HISTORIC AND DESIGN REVIEW COMMISSION

July 20, 2022

HDRC CASE NO: 2022-130
ADDRESS: 334 W ELSMERE PLACE
LEGAL DESCRIPTION: NCB 3967 BLK 2 LOT E 25 FT OF 3 & W 25FT OF 4
ZONING: R-5, H
CITY COUNCIL DIST.: 1
DISTRICT: Monte Vista Historic District
APPLICANT: Tom Krulevitch
OWNER: Peter & Susana Krulevitch/KRULEVITCH PETER & SUSANA L
TYPE OF WORK: Exterior modifications, construction of a rear addition, rear accessory structure modifications and addition, site modifications
APPLICATION RECEIVED: February 10, 2022
60-DAY REVIEW: Not applicable due to City Council Emergency Orders
CASE MANAGER: Hannah Leighner

The applicant is requesting a Certificate of Appropriateness for final approval to:

A-1

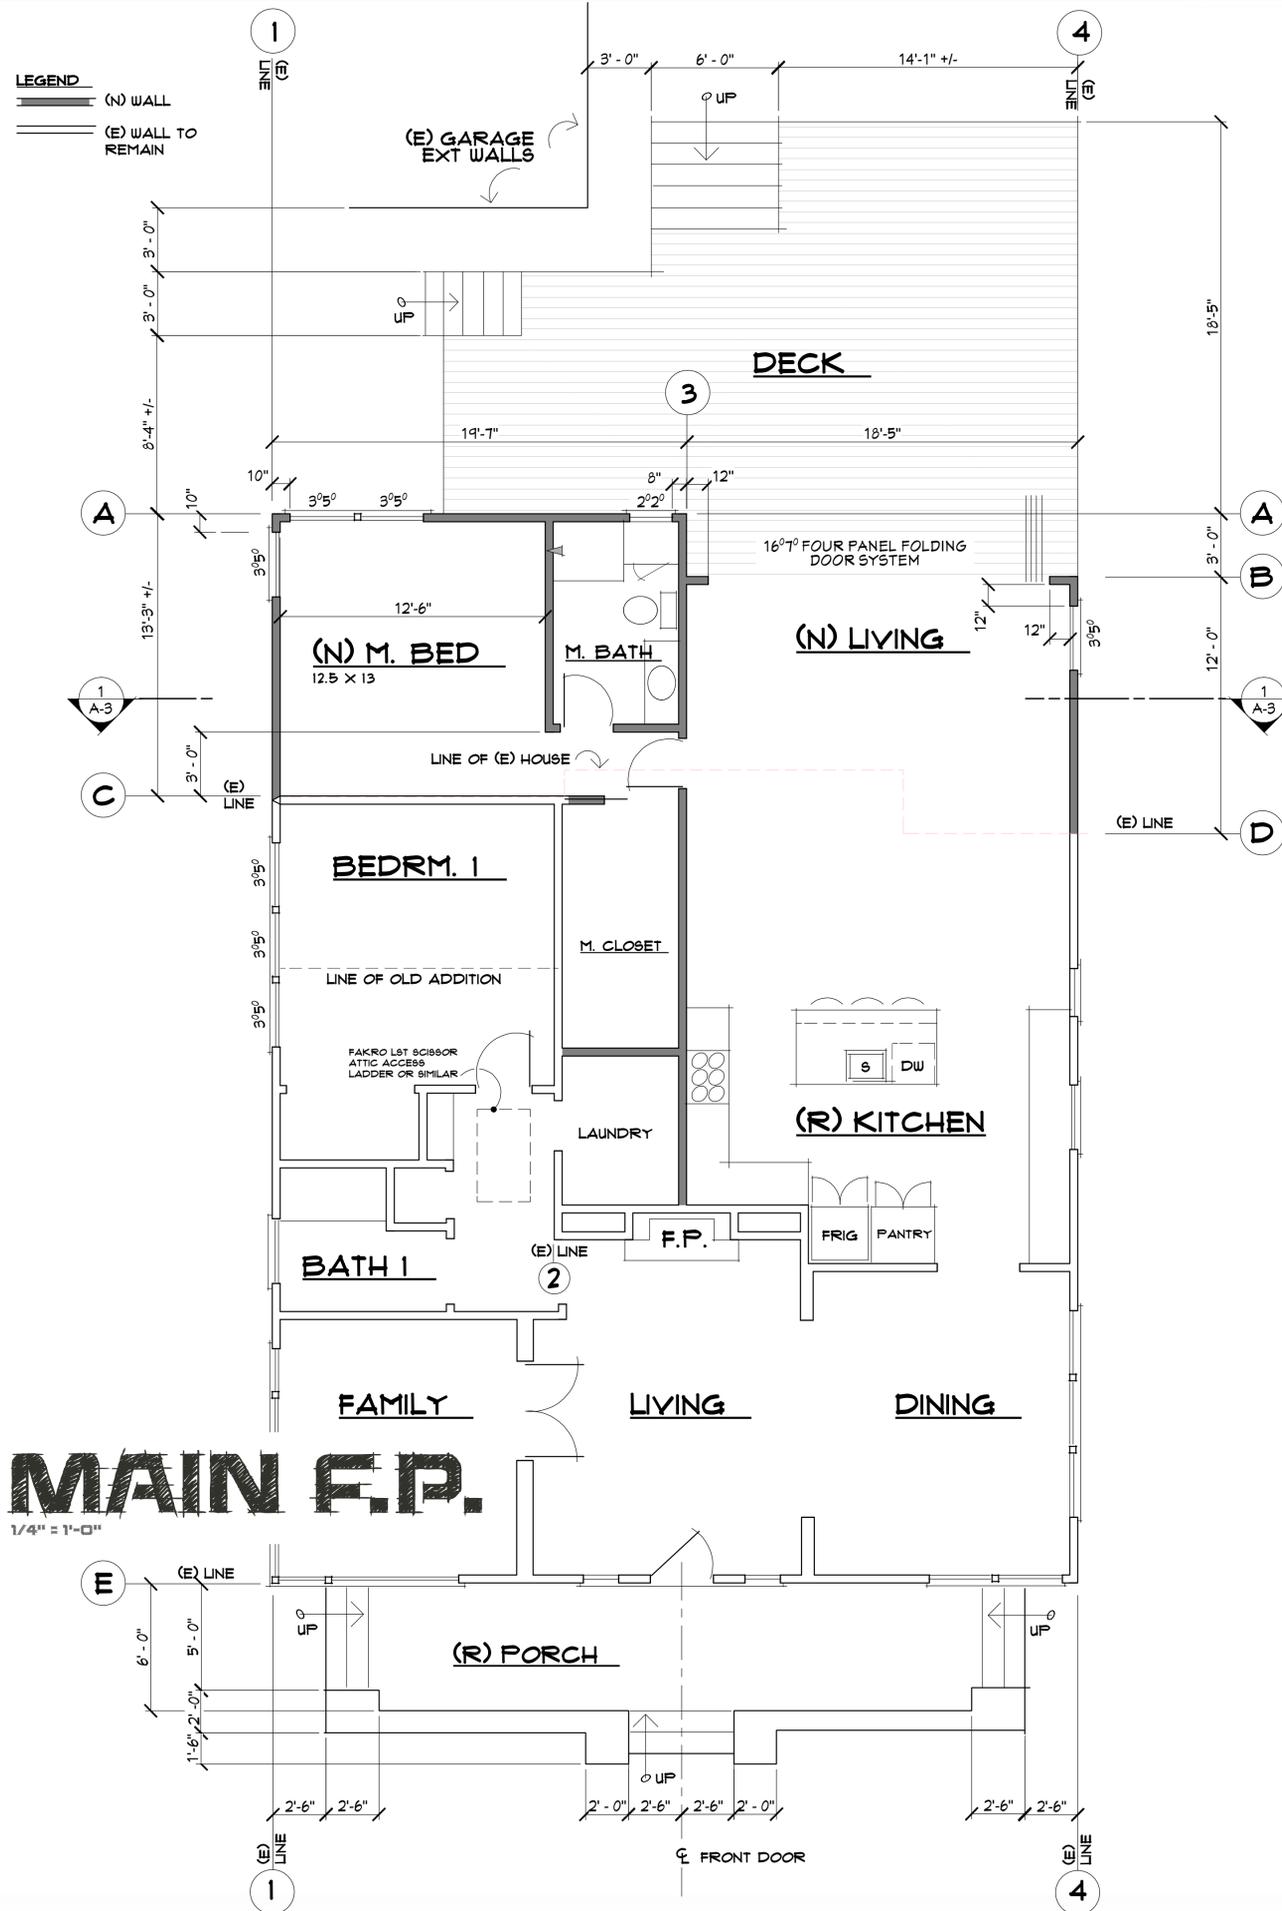
- c. FRONT PORCH MODIFICATIONS – The applicant has proposed to modify the existing front porch configuration. The current porch features an arched shed overhang and a concrete pad that is slightly larger than the overhang. The proposal will not affect the overhang. The proposal includes removing the existing steps and pad and extending the uncovered porch to the full width of the front façade. Short walls with faux column bases will be included. Per the Guidelines, front porches should be retained. Design replacement elements, such as stairs, to be simple so as to not distract from the historic character of the building. Do not add new elements and details that create a false historic appearance. The porch configuration appears to be original to the structure and is characteristic of other structures of a similar design in the Monte Vista Historic District and nearby neighborhoods of a similar development period. Staff does not find the modifications consistent with the Guidelines.

1. Staff does not recommend approval of item 1, modification of the front porch, based on finding c. Staff recommends that the applicant retains the existing front porch configuration.

MAIN ELEVS
PROPOSED
1/4" = 1'-0"

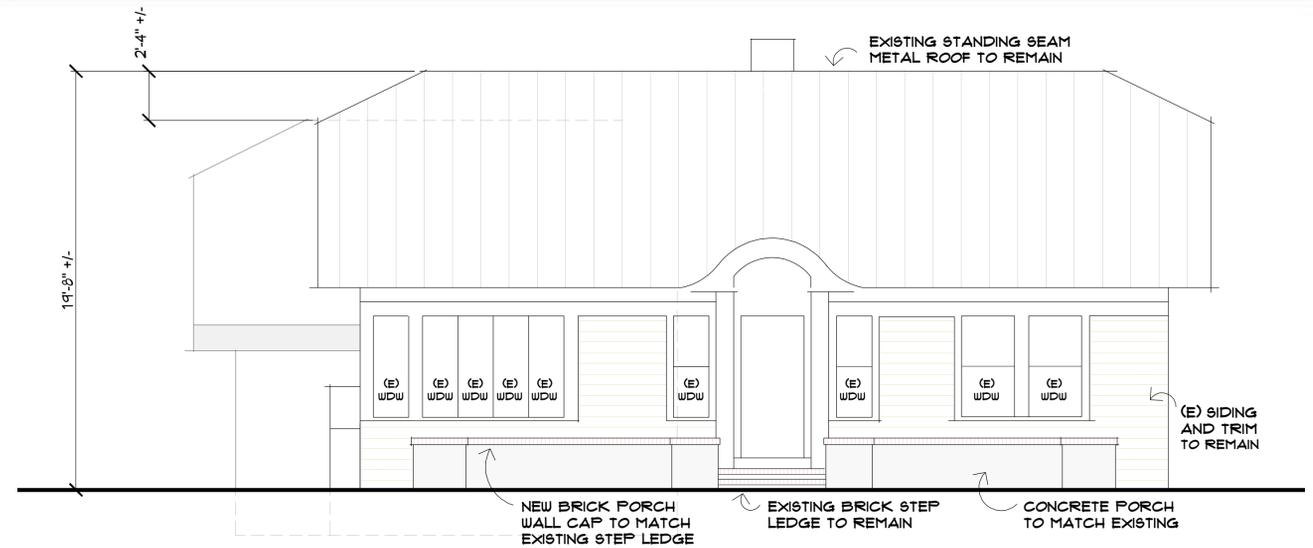
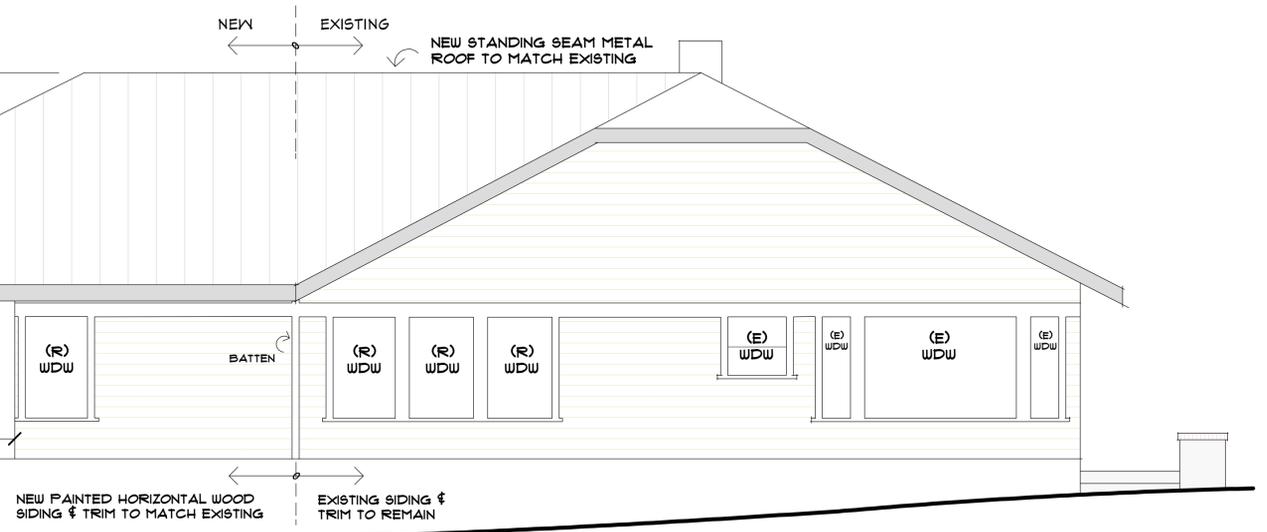
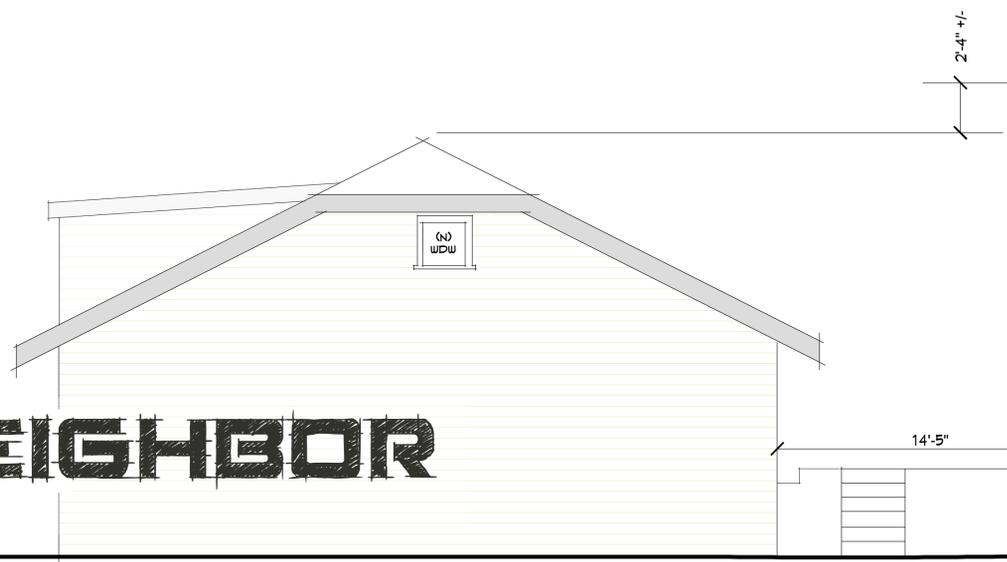
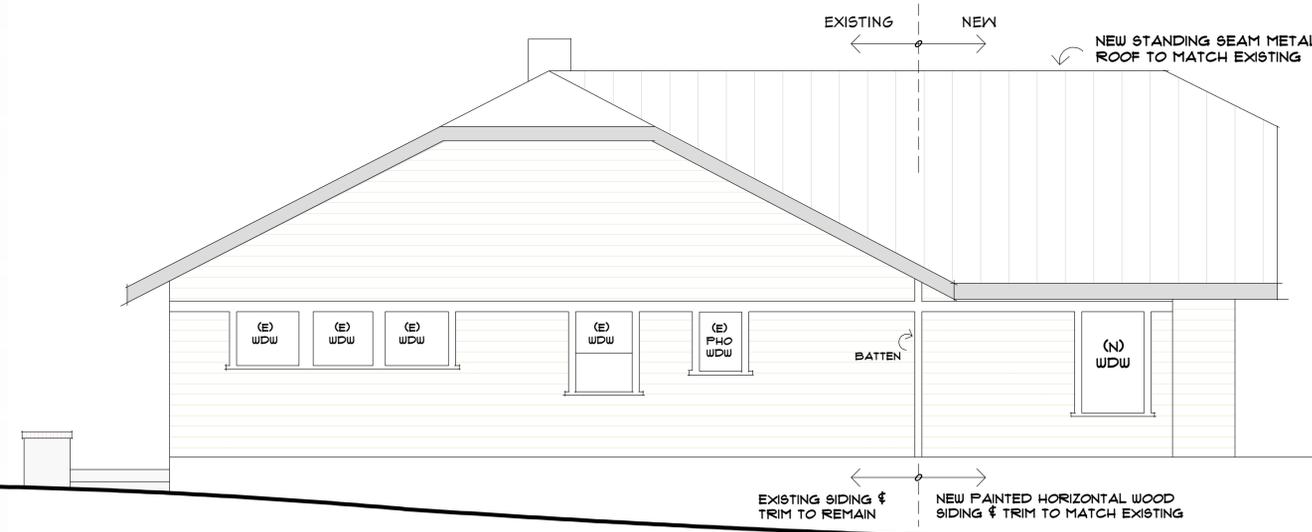
- d. ADDITION: MODIFICATIONS TO EXISTING STRUCTURE – The applicant has proposed to construct a 1-story rear addition to the existing 1-story historic house, which will require exterior modifications to the existing structure. Based on submitted photographs and the conceptual documents, the proposed modifications appear to include the removal of an existing window and door configuration on the rear elevation. Staff finds that the removal of elements of the rear addition are acceptable for the new addition and recommends that any salvageable elements be reutilized in the new addition.

- e. ADDITION: FOOTPRINT – The applicant has proposed to construct a 1-story rear addition. According to the Historic Design Guidelines, new additions should never result in the doubling of the historic building footprint. Staff generally finds the footprint to be consistent with the guidelines.

- f. ADDITION: SCALE AND MASSING – The applicant has proposed to construct a 1-story rear addition. According to the Historic Design Guidelines, the height of additions should be subordinate to the primary structure or, at minimum, align with the primary ridgeline. Staff generally finds the height consistent with the Guidelines based on the submitted documentation.

- g. ADDITION: ROOF – The applicant has proposed to install a standing seam metal roof on the addition to match the primary structure. The roof will feature a gable configuration. Staff finds the proposal conceptually consistent with the Guidelines.

- h. **ADDITION: WINDOWS AND DOORS** – Per the submitted documentation, the addition will feature accordion-style doors and a set of three wood windows on the rear elevation. The right and left elevations of the addition will each feature one traditionally-sized, wood window. According to the Historic Design Guidelines, new windows on additions should relate to the windows of the primary historic structure in terms of materiality and overall appearance. Windows used in new construction should relate be similar in appearance to those commonly found within the district in terms of size, profile, and configuration. As noted in finding d, the applicant should reclaim windows to be removed for the addition where feasible. While no material is expressly prohibited by the Historic Design Guidelines, a high-quality wood or aluminum-clad wood window product often meets the Guidelines with the stipulations listed in staff’s specifications and the recommendation if new windows or doors are needed.

- i. **ADDITION: MATERIALS** – The applicant has proposed to install new painted horizontal wood siding and trim, and a standing seam metal roof to match the historic structure. The addition will also feature wood windows of various sizes. Staff finds the proposed materials to be appropriate.

2. Staff recommends approval of item 2, construction of a rear addition on the primary structure, based on findings d - i with the following stipulations:

- i. That the applicant salvage and reuse the windows to be removed for the rear addition as noted in findings d and h.
 - ii. that the applicant provides clear, measured, dimensioned drawings that clearly convey what will be retained and what elements are new for the addition.

ADU ELEVS
PROPOSED
1/4" = 1'-0"

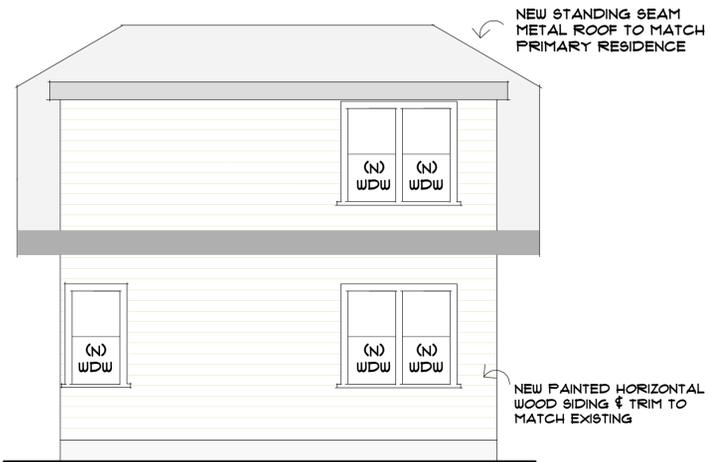
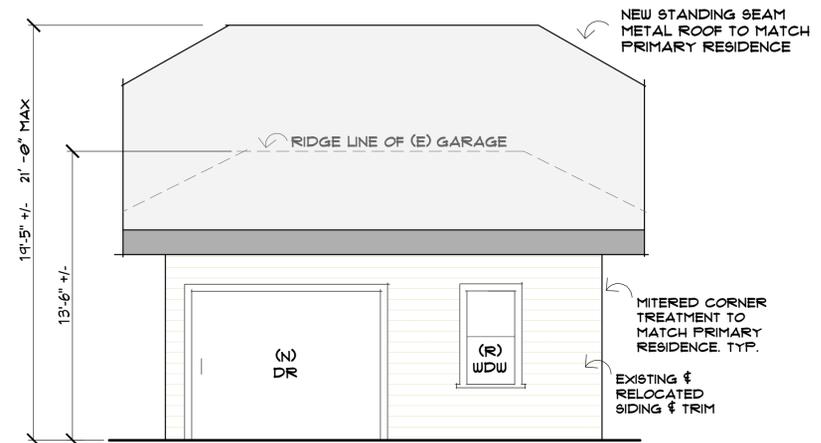
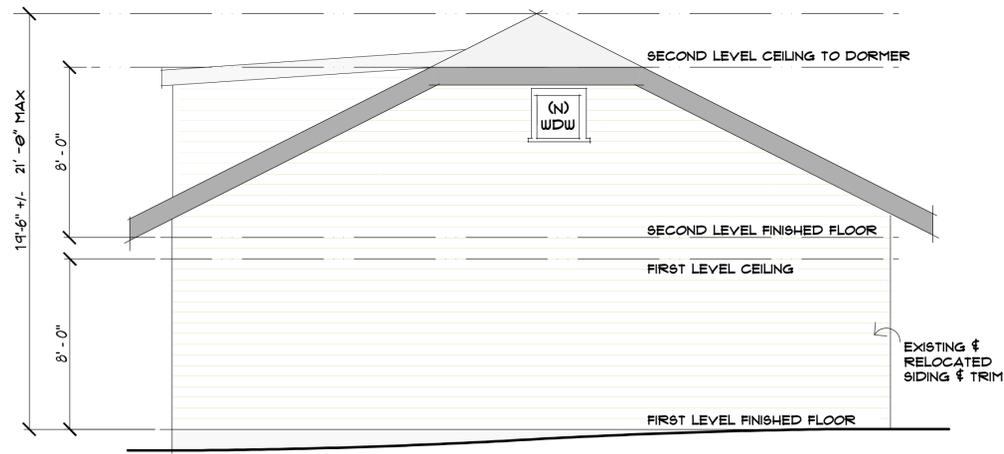
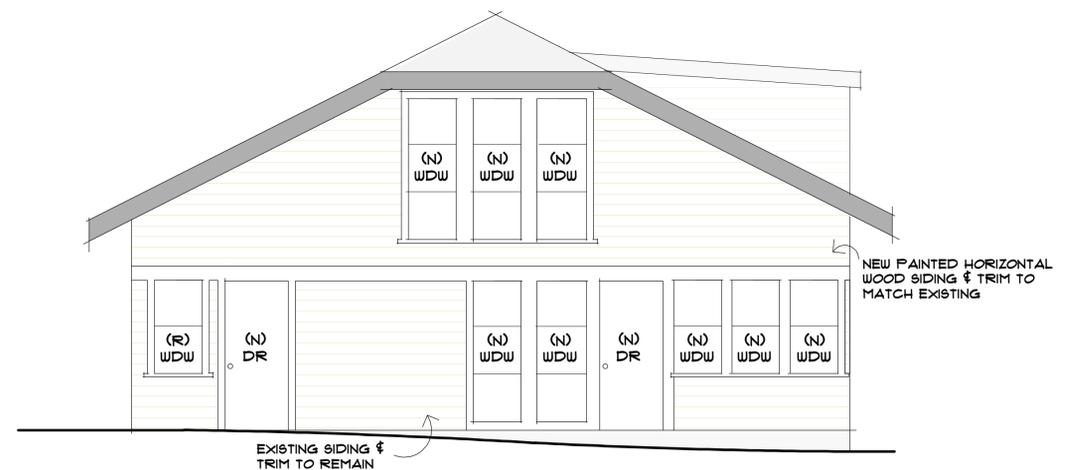
- j. **REAR ACCESSORY STRUCTURE MODIFICATONS** – Per the submitted documents, two walls of the existing rear garage will be removed, resulting in new footprint to support a second story addition and additional exterior modifications. The two remaining walls will be retained and incorporated into the new design, which features a taller primary roofline, a new fenestration pattern, and new exterior garage doors facing the street. Staff finds that applicant should aim to maximize material salvage from the walls to be removed for reuse in the new design and submit a clear salvage and reuse plan.

3. Staff recommends approval of item 3, modification of the rear accessory structure, based on finding j with the following stipulations:
 - i. That the applicant provides clear, measured, dimensioned drawings that clearly convey what will be retained and what elements are new for the ADU

- ii. That the applicant submit a line of site study for the ADU that shows the comparative height of the ADU and the primary structure.
